## **Regulatory Improvement Code Amendment Package 3**

## **Recommended Draft Report**

**August 22, 2007**

**Figure 266-3**  
**Landscaped area at front of parking space.**

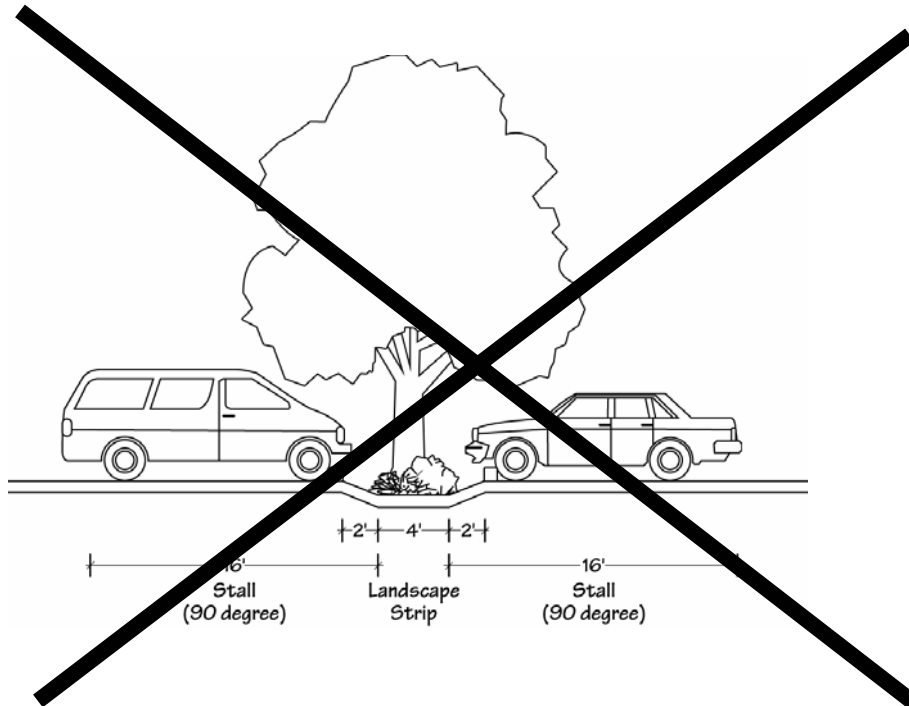
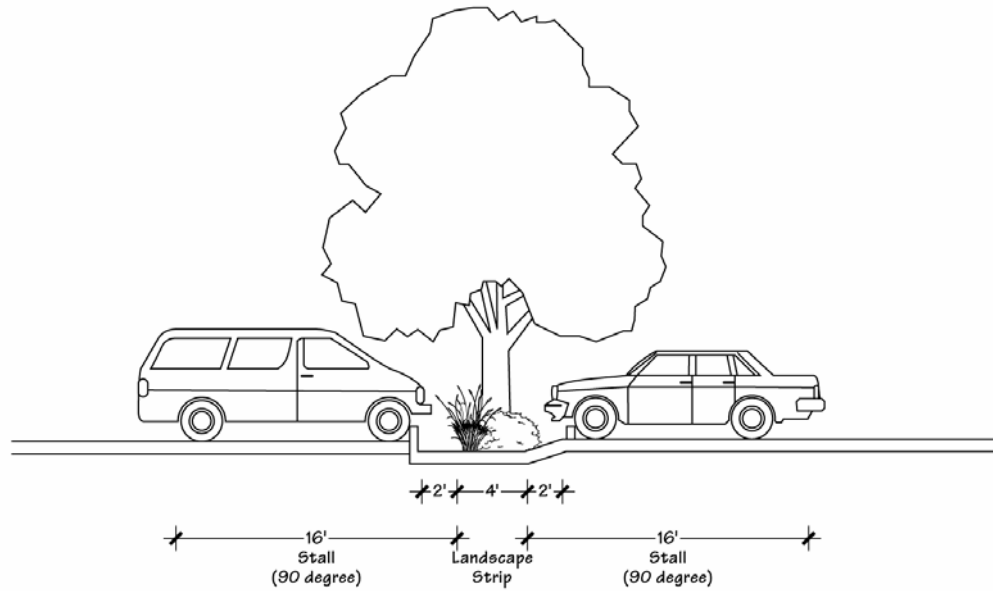
4. The parking standards allow part of a parking space beyond the wheel stop to be landscaped instead of paved. This area is usually overhung by the vehicle. To provide structural support for the wheel stop, sometimes parts of this area need to be paved. These amendments clarify that this area can be paved, landscaped, or a combination of the two.

4. A portion of a standard parking space may be landscaped instead of paved, as follows:
  - a. ~~The landscaped area may be~~ As shown in Figure 266-3, up to 2 feet of the front of the space as measured from a line parallel to the direction of the bumper of a vehicle using the space, as shown in Figure 266-3 may be landscaped area;
  - b. Landscaping must be ground cover plants; and
  - c. ~~The landscaped area within the parking space~~ The portion of the 2-foot wide area described in 4.a that is landscaped counts towards parking lot interior landscaping requirements and toward any overall site landscaping requirements. However, the landscaped area does not count toward perimeter landscaping requirements.
5. [No Change]

**Figure 266-5  
Landscape Strips**

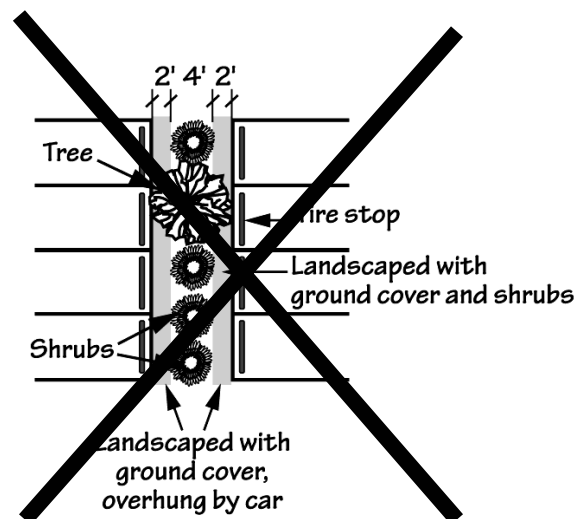
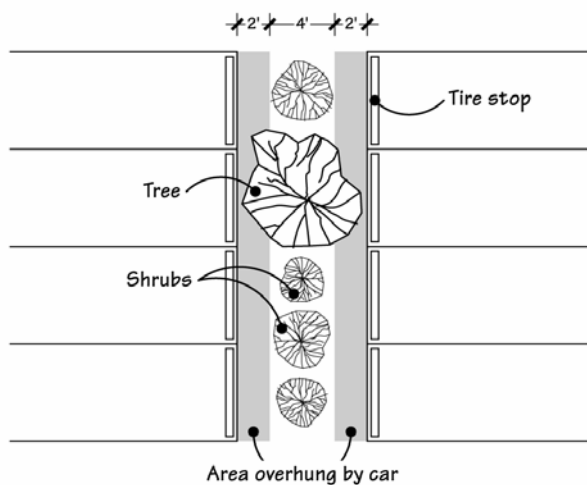
- Interior landscaping must be arranged in landscape strips at least four feet wide between rows of parking stalls, as shown in Figure 266-5.
- Where the front portions of parking stalls are landscaped as allowed by Paragraph F.4, the landscaped portion of the parking stall must be ~~added adjacent~~ adjacent to the four-foot landscape strip, ~~widening the strip to at least six feet for one row of parking stalls and at least eight feet for two rows of stalls,~~ as shown in Figure 266-5.

**Figure 930-5**  
**Measuring Height – Roof Types**

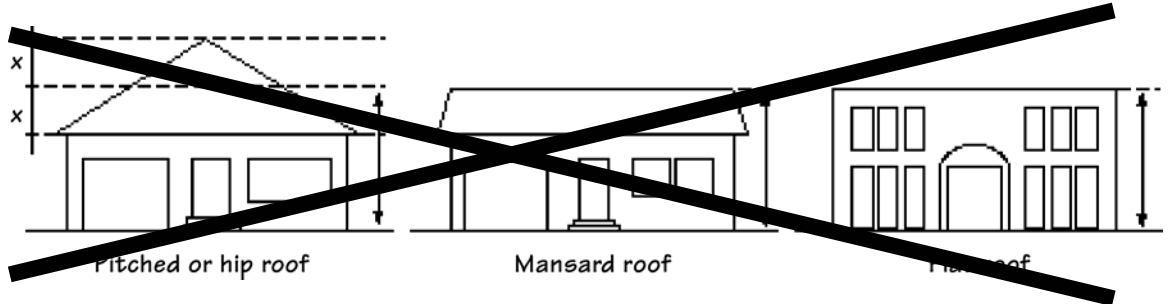
Garages (and converted garages) are allowed to be in the setback if their wall height does not exceed 10' excluding the portion of wall within the gable. There have been some problems applying this standard to gambrel and other more unusual roof shapes. This amendment adds a regulation to limit overall building height to 15' to help limit the overall mass of garages. This height limit will be used with revised measurement guidelines and illustrations in 33.930 to clarify how to measure a gambrel roof.

**Figure 930-5.** This figure is amended to provide a fourth example illustrating the height measurement for a gambrel roof.
